Mill Street Cut curb + gutter ADA Sidewalk

Elevation View

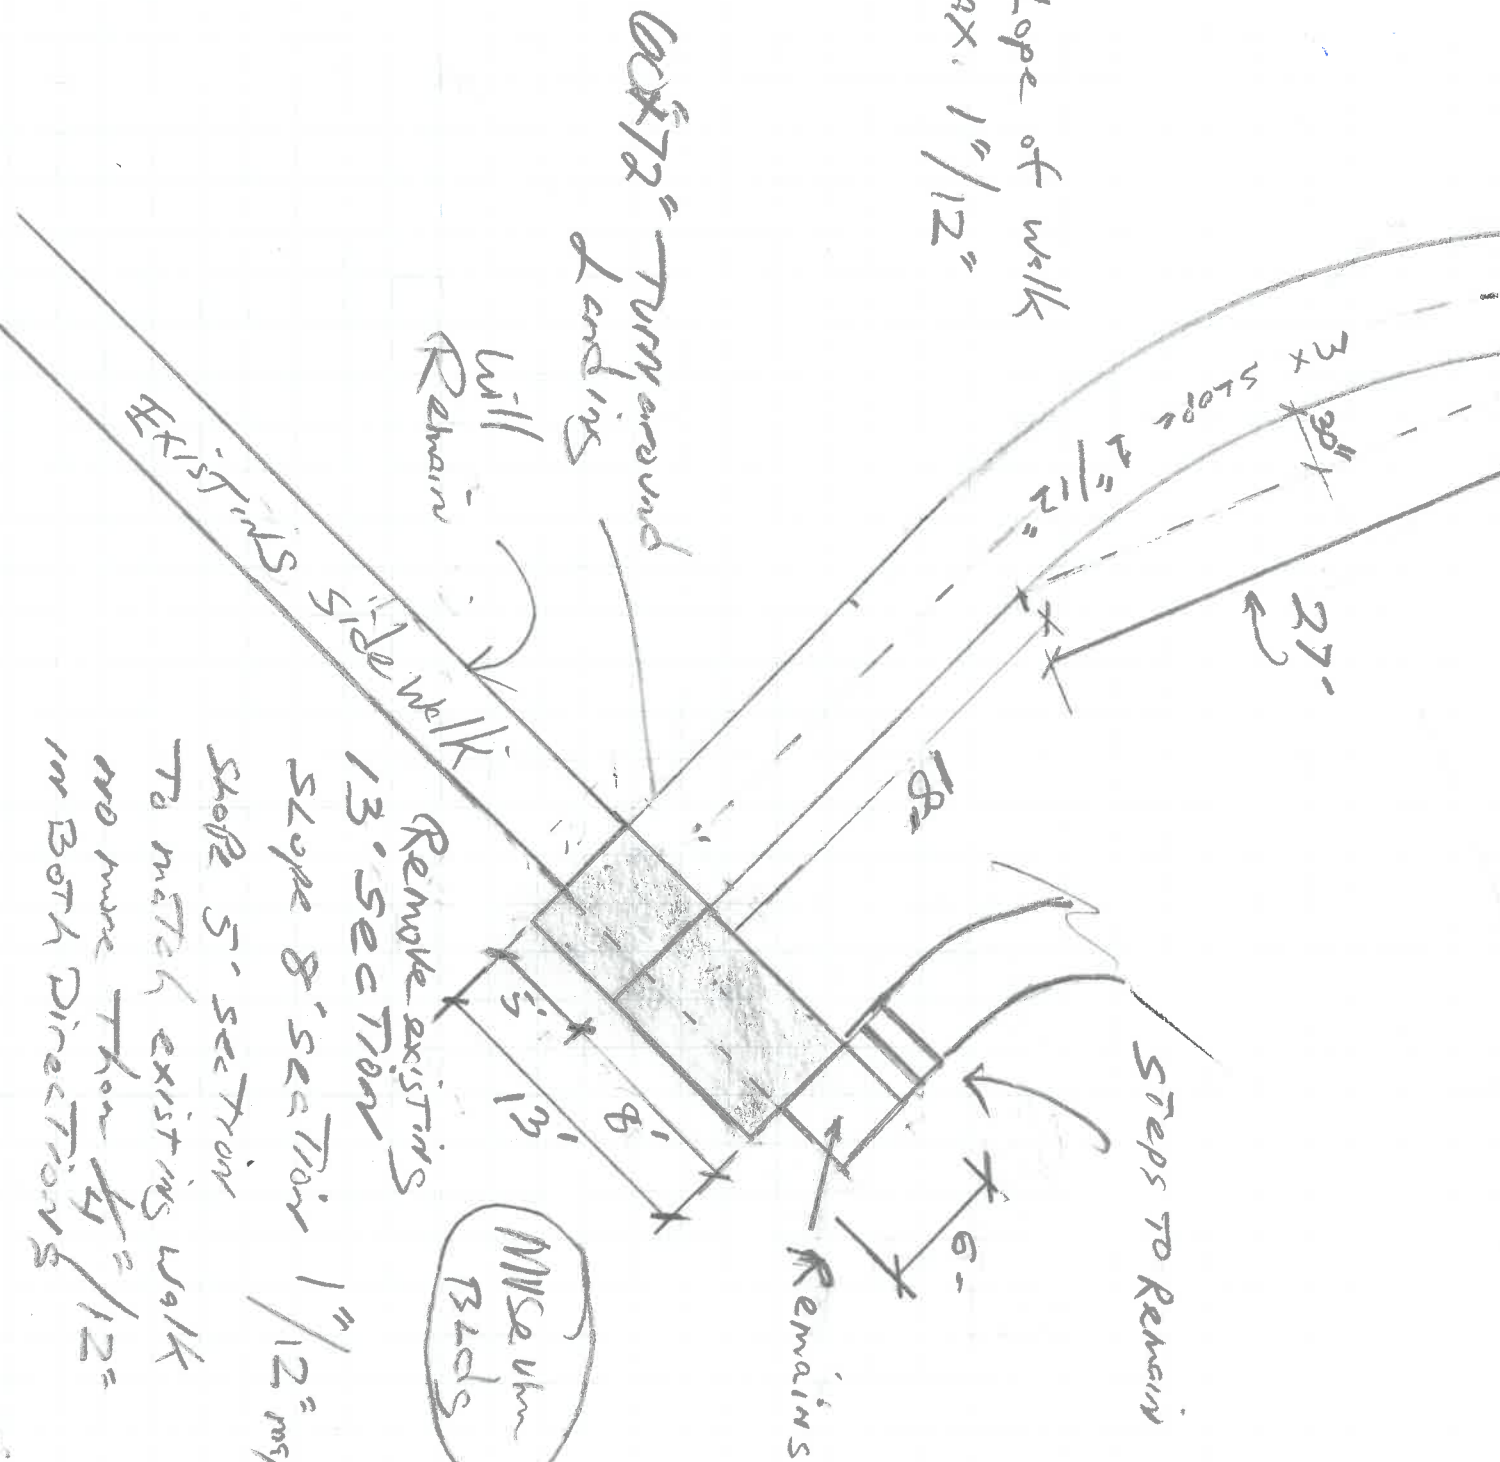
Slope of walk
MAX. 1"/12"

NOTE: Current Slope of 13' section is 8"
Recommended Slope 8' section - 7"
@ New walk: 5' section - 1"
